**RE: Westgate Community Center  
10001 DeVargas Rd SW  
Grading and Drainage Plan  
Engineer's Stamp Date: 8/12/19  
Hydrology File: M09D030**

Based on the submittal received on 8/14/19, the Grading and Drainage Plan cannot be approved until the following corrections are made:

**DRAINAGE MANAGEMENT PLAN**

## OVERALL GRADING AND DRAINAGE PLAN

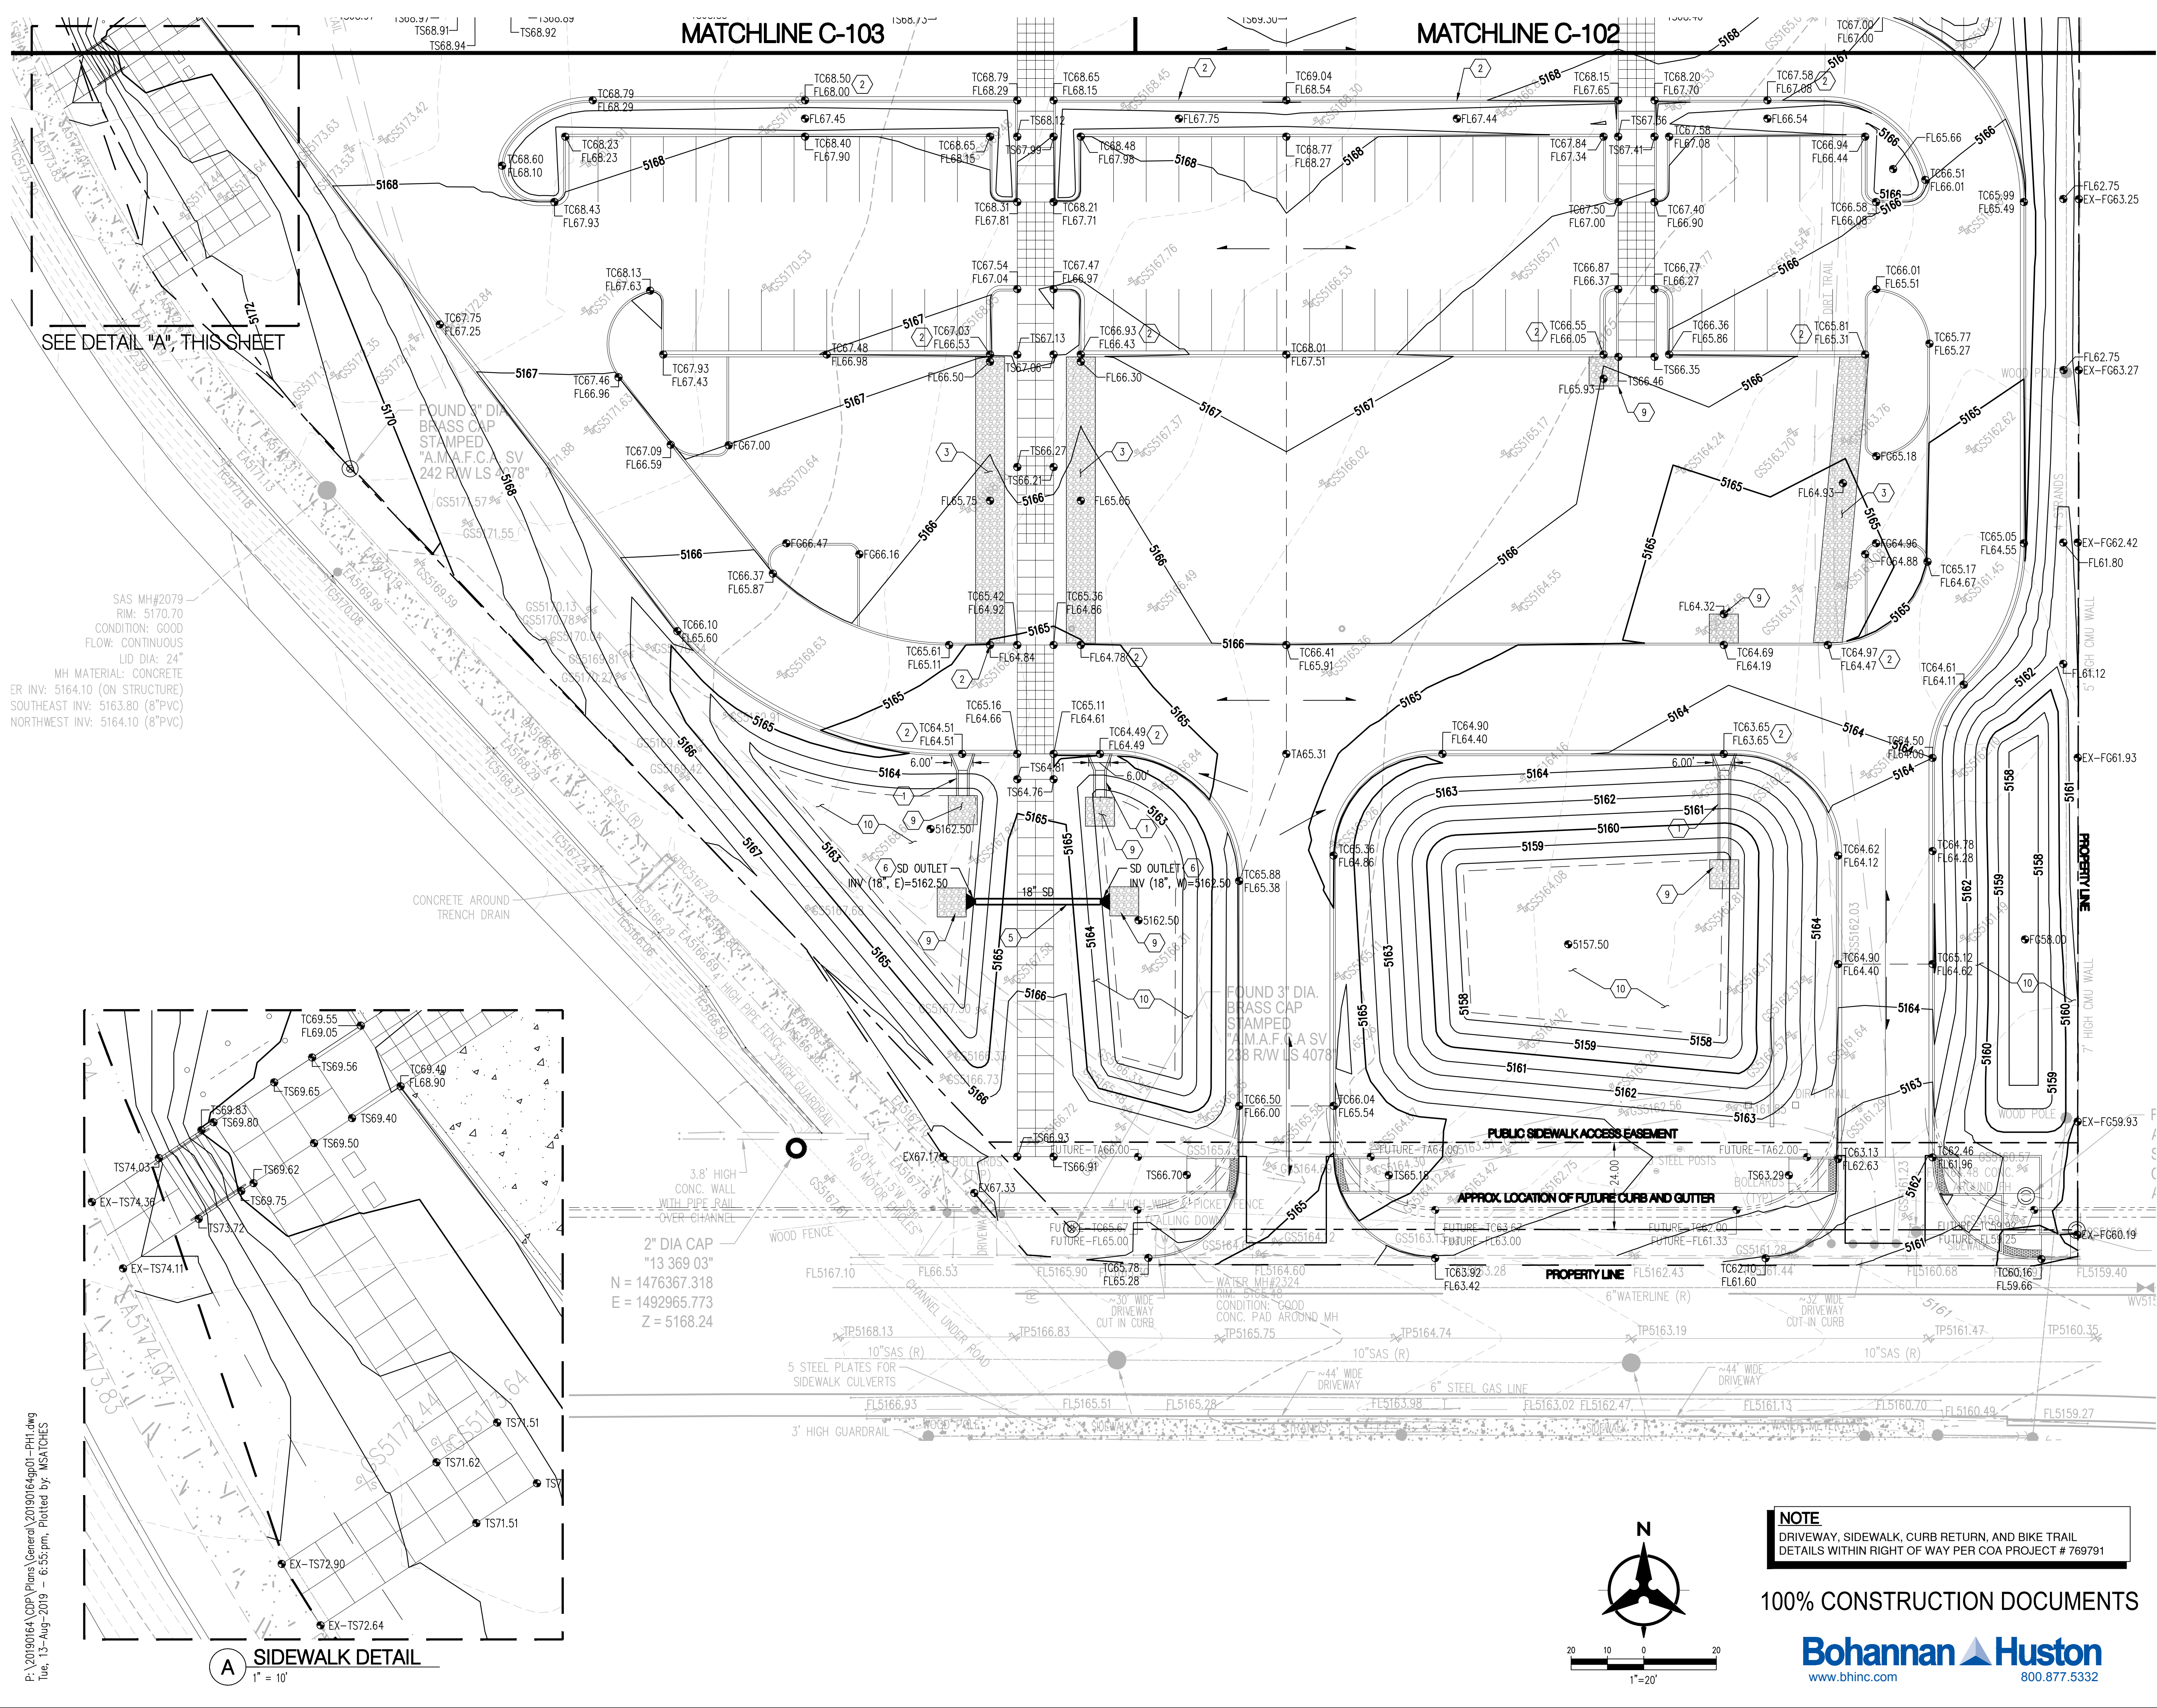
1. Provide hydraulic calculations for the riprap swale along the north side of the project; and calculations from Pond 1 back on the plan.
2. Put the concrete swale (emergency overflow) from pond 1 back on the plan. Any alternative design needs to be designed and stamped by a professional engineer and provided on the stamped grading plan.

7. Will the basin B-2 area be used for staging? It needs to be reseeded if so; specify reseeding per section 1012 for all disturbed areas.
8. Depress the landscaping in the parking islands to provide additional water quality and allow water to enter the islands instead of ponding/ backing up in the parking spots.
9. Screen-back or otherwise annotate what parking islands & curbs will be built now and which are future.

#### E RIP RAP SWALE

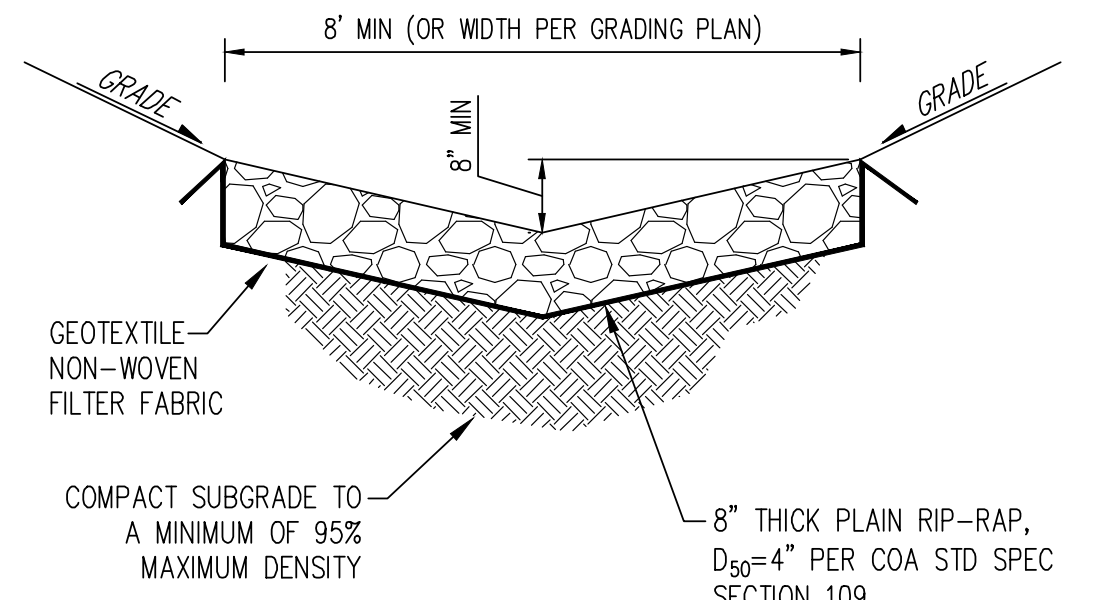
3. Put the riprap swale into pond 1 back on the plan. Any alternative design needs to be designed and stamped by a professional engineer and provided on the stamped grading plan.

4. Put the riprap swale along east property line back on the plan. Any alternative design needs to be designed and stamped by a professional engineer and provided on the stamped grading plan.
